ADDRESS: 1018 WINTER ST

Proposal: Demolish and reconstruct upper floors with roof deck

Review Requested: Final Approval

STAFF RECOMMENDATION: Denial, pursuant to Standards 2, 9, and 10.

A0

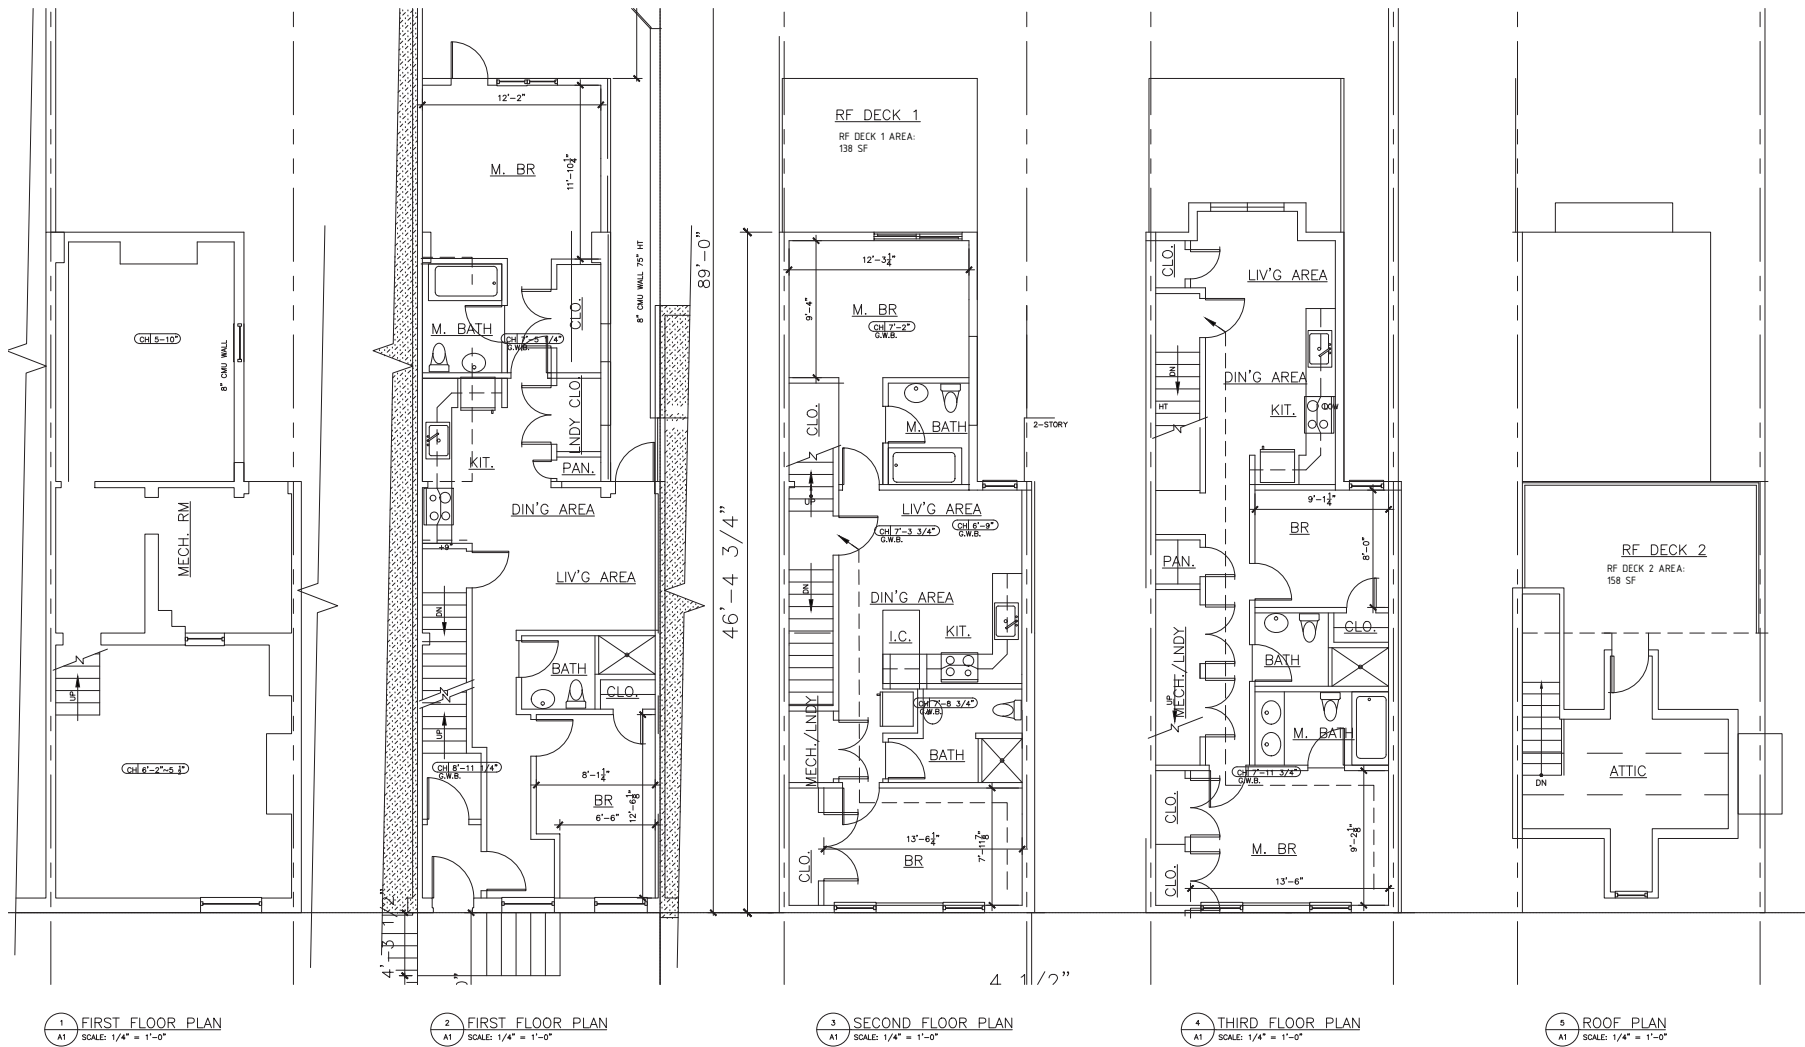
- *Standard 2: The historic character of a property will be retained and preserved. The removal of distinctive materials or alterations of features, spaces, and spacial relationships that characterize a property will be avoided.*
 - The application proposes a significant amount of demolition to the front of the building; therefore, the application does not meet Standard 2.

- If the front wall and roof must be replaced, as recommended in the structural report, they should be replaced in-kind and not include an additional floor level.

- The proposed alterations to the front façade do not meet Standard 9 in terms of scale and proportion.
 - The proposed increase in size and massing at the rear of the property overwhelms the original form and environment of the historic building and does not meet Standard 9.

- The proposed demolition and new construction permanently alter the historic building's form and integrity; therefore, the application does not meet Standard 10.

WEST ELEVATION
SCALE: 1/4" = 1'-0"

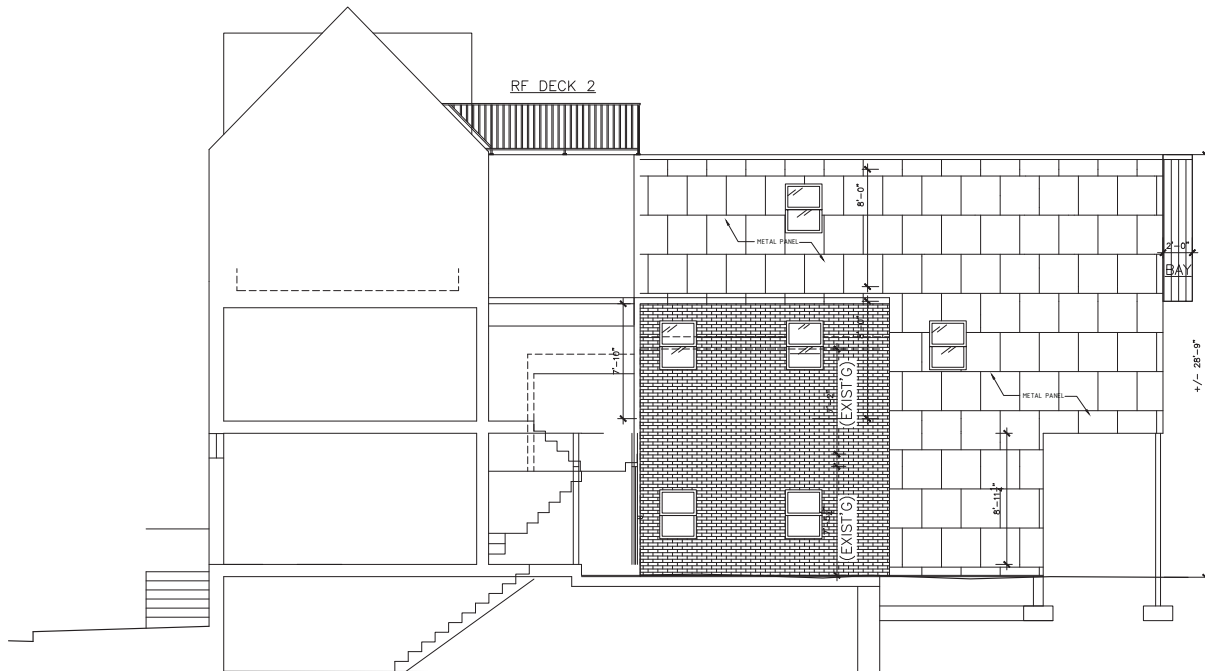
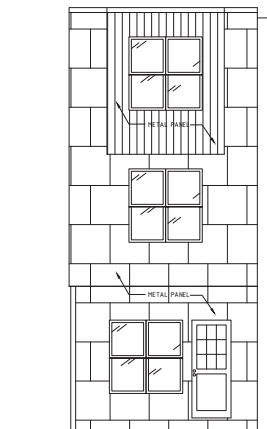
- The location of the proposed pilot house at the rear of the property could meet the Roofs Guideline if other aspects of the application were revised to meet Standards 2, 9, and 10.

Photo No. 2. View of the significant leaning of the front wall

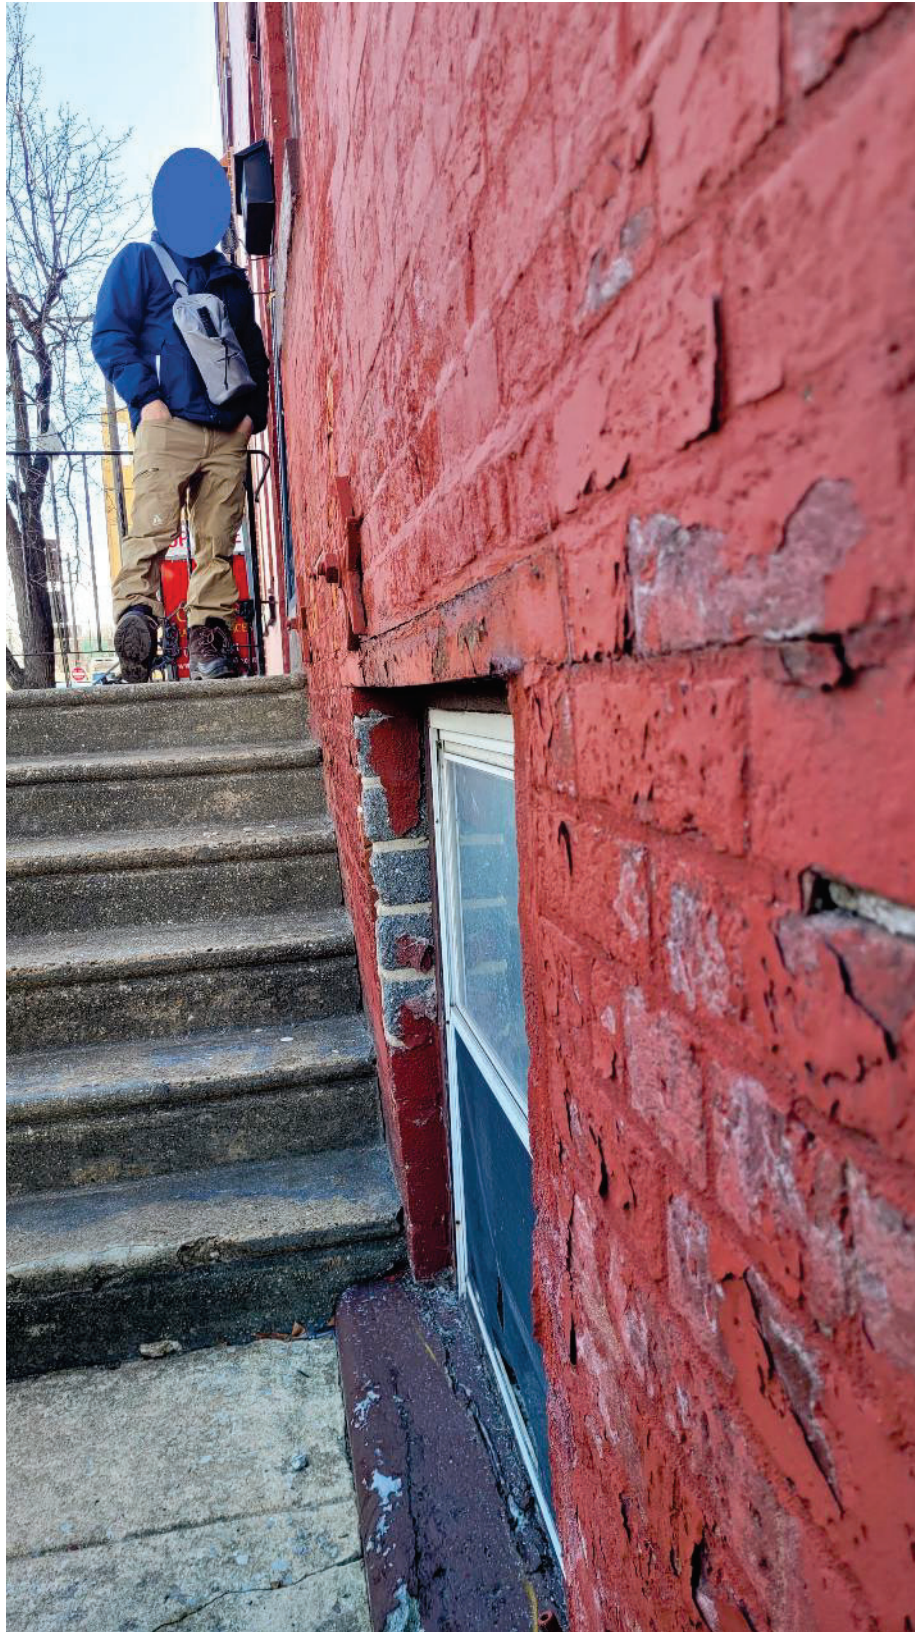
1. The front wall of the building is noted to have star bolts already installed. However, the front wall is noted to be significantly leaning (see Photo No. 2-5). It is recommended that the front wall be fully demolished and reconstructed, including the front foundation wall.

1. Remove and replace front wall and front steps
2. Remove and replace the roof framing throughout
3. Remove and replace all staircase framing
4. Remove and replace the deteriorated wood floor framing and sister the remaining floor joists
5. Rear masonry wall can remain with local repairs
6. Alley masonry wall can remain with local repairs

**Photo No. 9. View of the decrepit and deteriorated brick masonry throughout the front
façade**

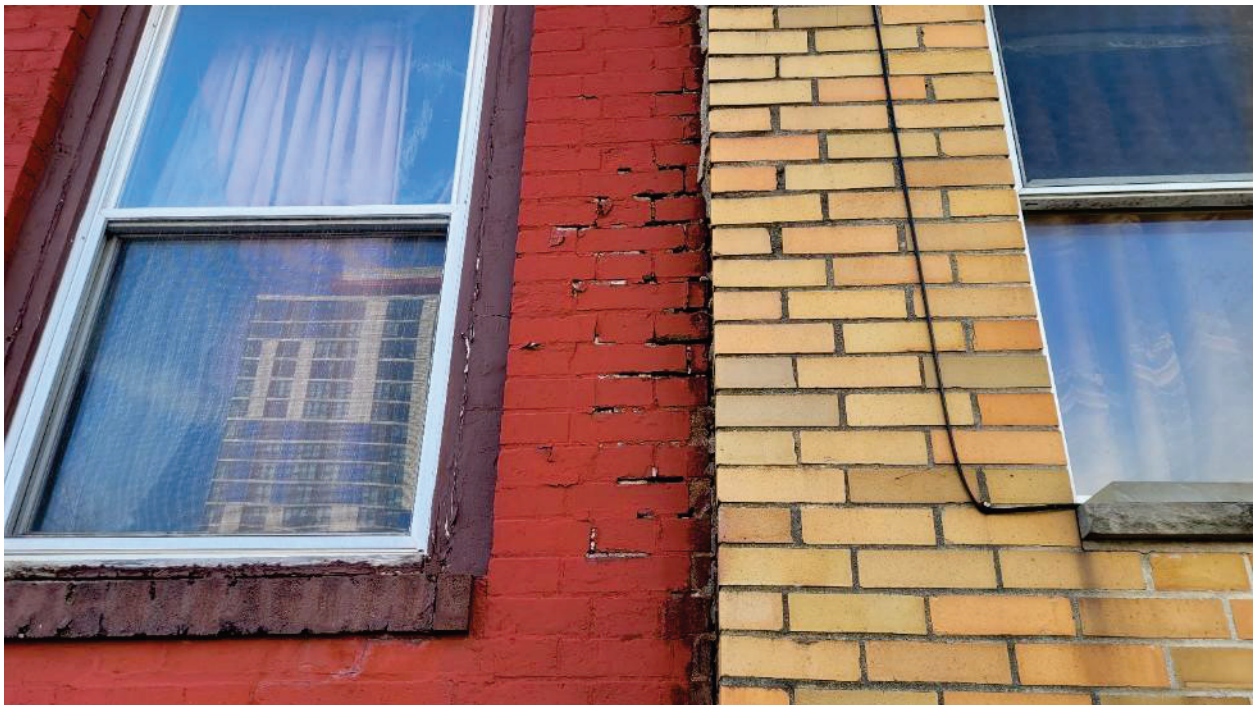
- b. The windowsill of the front 1st floor window is noted to be sagging and exhibits cracking (see Photo No. 8).
 - c. The brick masonry of the front façade is noted to have multiple decrepit and deteriorated sections throughout (see Photo No. 9-11).

Photo No. 27. View of the rotted roof along the middle of the building, above the interior staircase

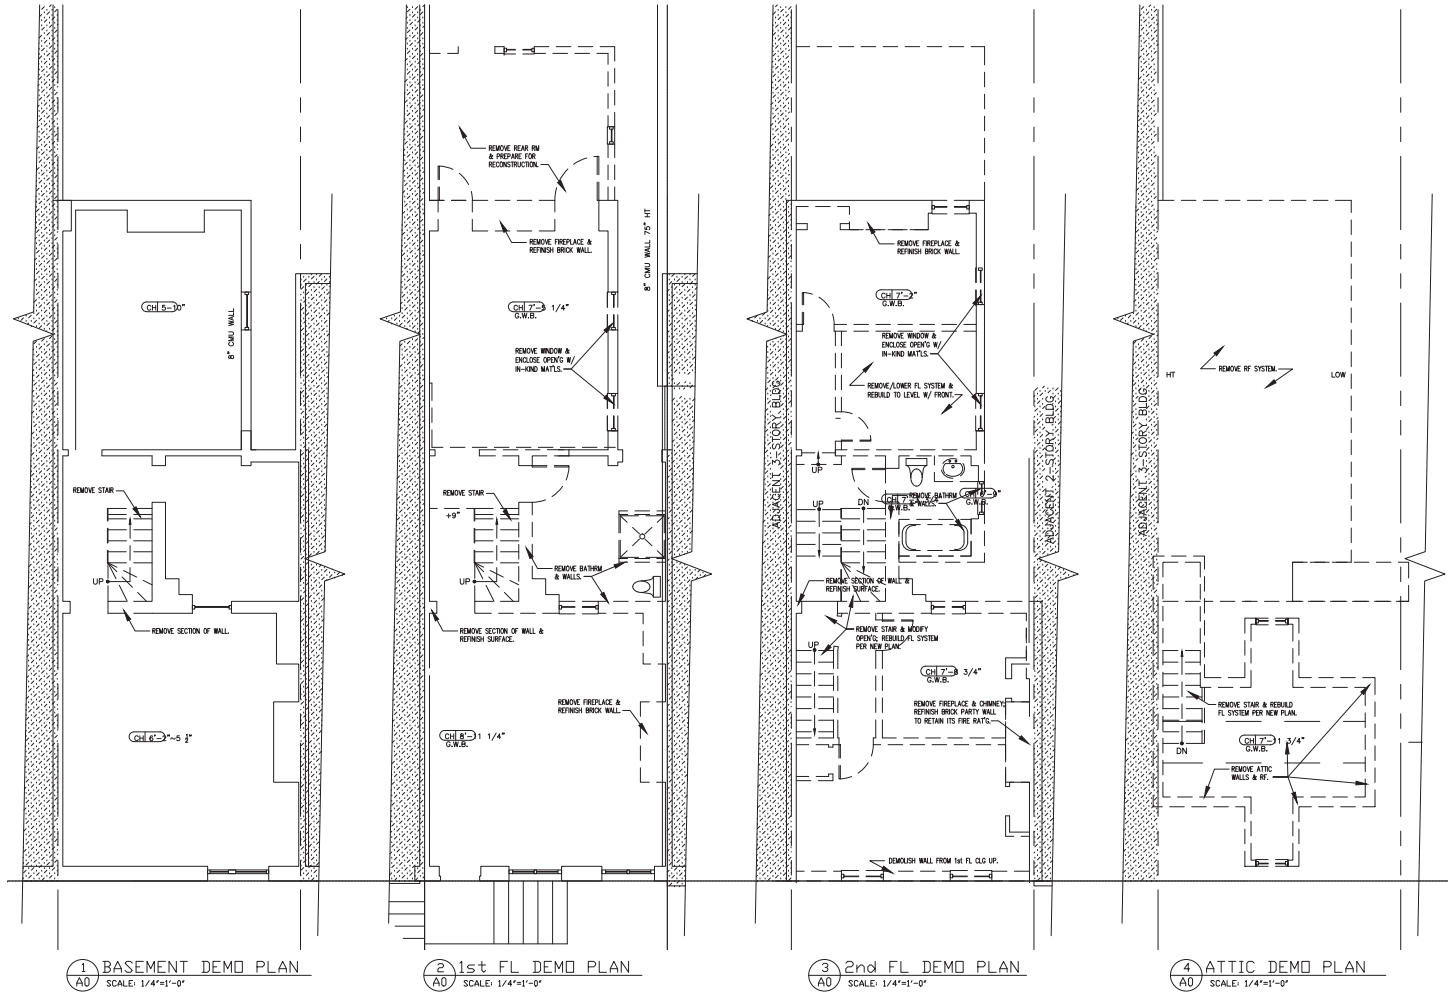
6. The roof along the middle portion of the building, above the interior staircase, is noted to have significantly rotted due to water infiltration (see Photo No. 27). It is recommended that the rotted roof framing be locally removed and replaced, and the roof made weather-tight.
